PLANNING, ZONING, & BUILDING DEPARTMENT  
PZ&B Staff Combination Memorandum: Architectural Commission and Town Council

SUBJECT: ARC-24-0030 (ZON-24-0015) 410 SEABREEZE AVE

MEETING: AUGUST 28, 2024 ARCOM  
SEPTEMBER 11, 2024 TC

*Existing Front (North) Elevation.*

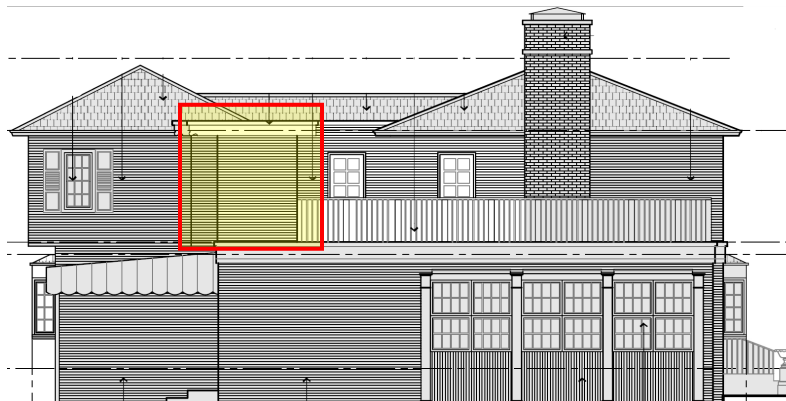
The subject property is a midblock parcel located on the south side of Seabreeze Avenue. The residence was constructed in the 1930's and designed by Gustav Maass for Mr. & Mrs. Van Voorhees in a colonial style. Numerous permits have been issued throughout the years for renovations, additions and maintenance to the structure. The existing structure is sited roughly mid parcel with existing nonconforming side yard setbacks. The proposed improvements to the structure are within the existing footprint. The applicant is proposing a second story addition at the existing second floor balcony on the rear east side of the structure. The addition is relatively small at less than 150 SF, however, variances are required to achieve the scope of work (outlined below). The roof of the addition will be flat to match the existing flat roof at the second story rear wood siding will be painted to match existing, and faux windows will be installed to match existing. A bay window is also proposed at the rear first floor of the house. Windows and door on the east second floor elevation will be removed to achieve the addition. There are no modifications proposed to hardscape or landscape on the site.

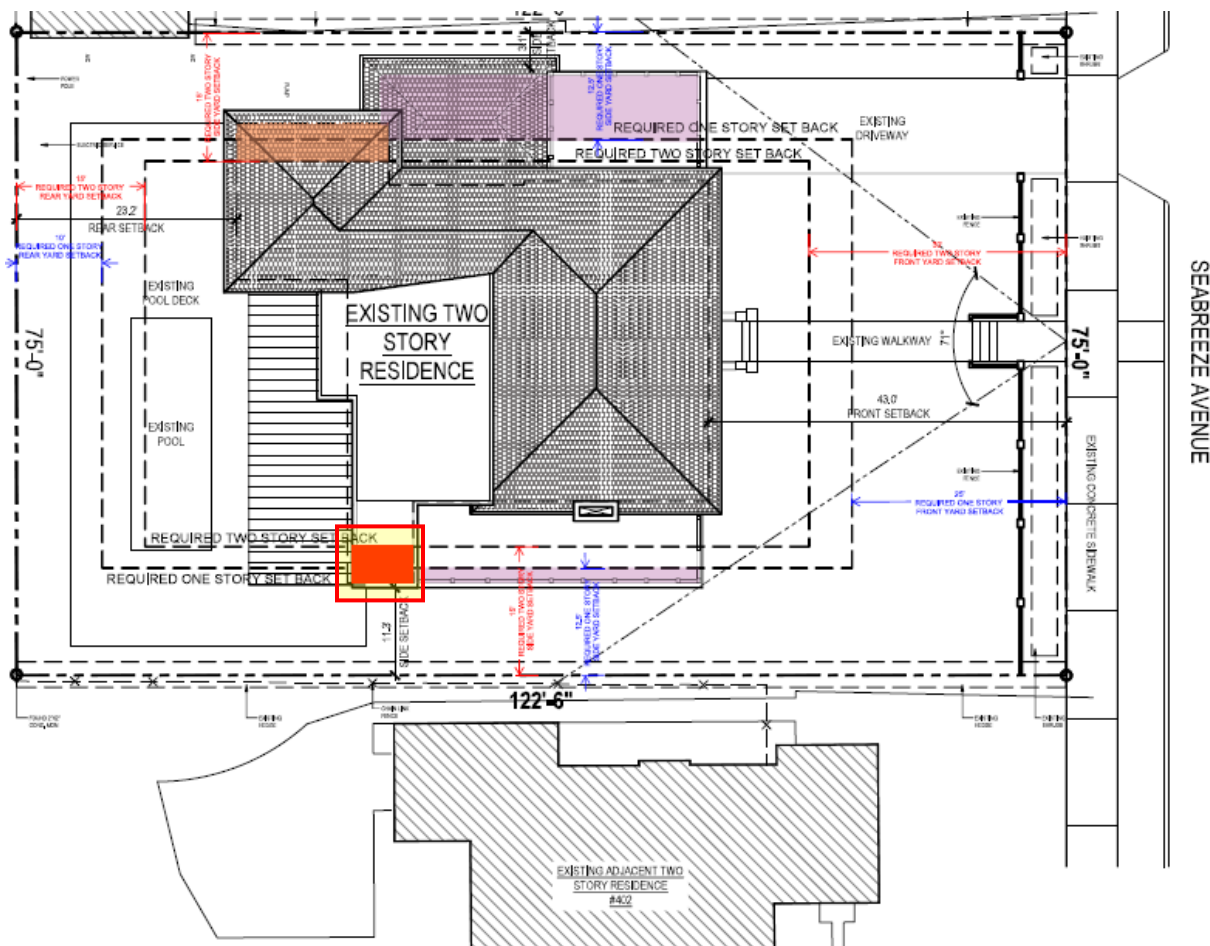
As it pertains to VARIANCE 1, the second story addition is proposed at 11.3' east side yard setback in lieu of the 15' second story side yard setback required. At 11.3', this would match the existing nonconforming first story setback. Staff will note that the existing second story east side yard setback is conforming, and granting of this variance would create another new nonconformity on the parcel. Staff will also note that the west side yard setback is nonconforming for both the first and second story, however, no changes are proposed on this elevation. As mentioned above, the Town Council granted variances in 2008 for the nonconforming first floor setback at the east side, as well as a setback variance for a similar second-floor addition on the west side.

Code Section	Required	Proposed	Variance
<b>VARIANCE 1:</b> Sec. 134-893(b)(7)b.	15' Second Story Side Yard Setback	11.3' Second Story Side Yard Setback	3.7'

*Axonometric diagram of cubic content from rear.*

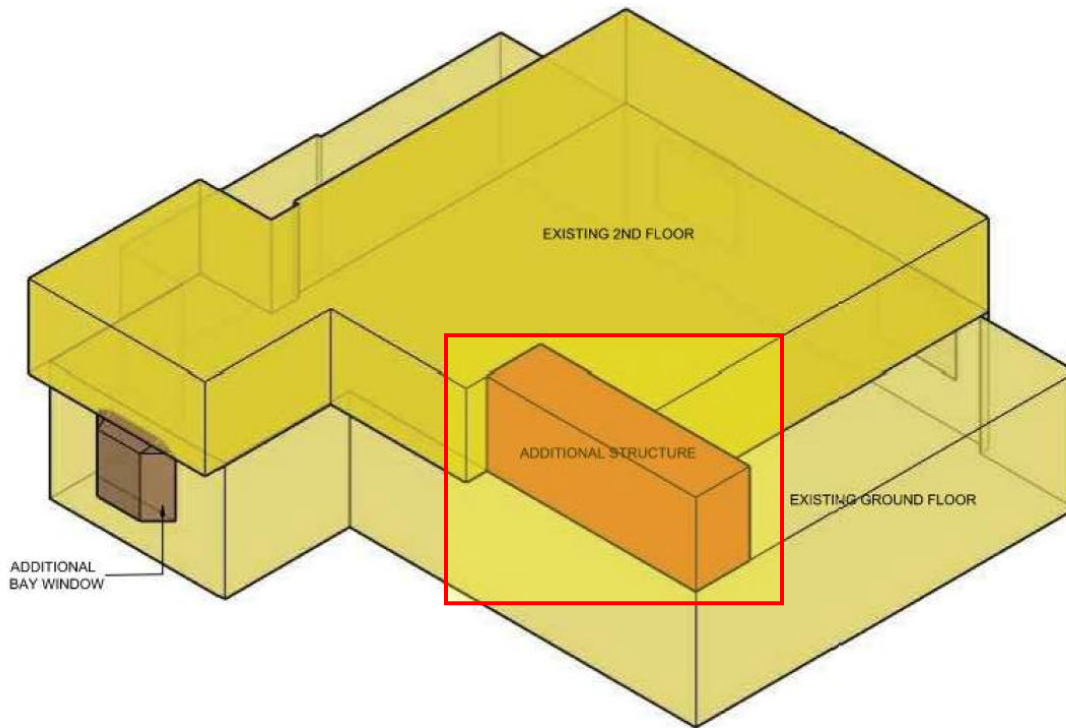
Variance 2 is to exceed the maximum cubic content ratio (CCR) permitted on site. As mentioned previously, the structure was built in the 1930s and therefore prior to today's zoning code. In 2008, the town council considered and granted a variance for a similar scope of work as it pertained to first and second floor additions to the nonconforming building, which permitted the expansion of the already nonconforming cubic content ratio.

The size of the addition is approximately 140 SF at 8.8' in height, adding an additional 0.14CF of mass to the already nonconforming structure. The addition is 21.9' wide (east to west sides) and 6.33' deep (north-front to south-back). The addition will match the existing flat roof, without new overall building height. While the relatively small second floor addition seamlessly blends in with the architecture of the 1930's residence, it still remains as a variance and its approval needs to provide hardship in order for the Town Council to grant. Perhaps, as the Code reform continues to examine all aspect of the zoning code, the Town Council could provide specific direction on a lesser standard of approval for CCR on older residential buildings in the Town as a means of further incentivizing their retention.

Code Section	Permitted	Proposed	Variance
<b><u>VARIANCE 2:</u></b> Sec. 134-893(b)(13)	4.08 Max CCR	4.89 CCR in lieu of 4.75 CCR existing	+0.14 CCR from exist. +0.81 CCR from max.
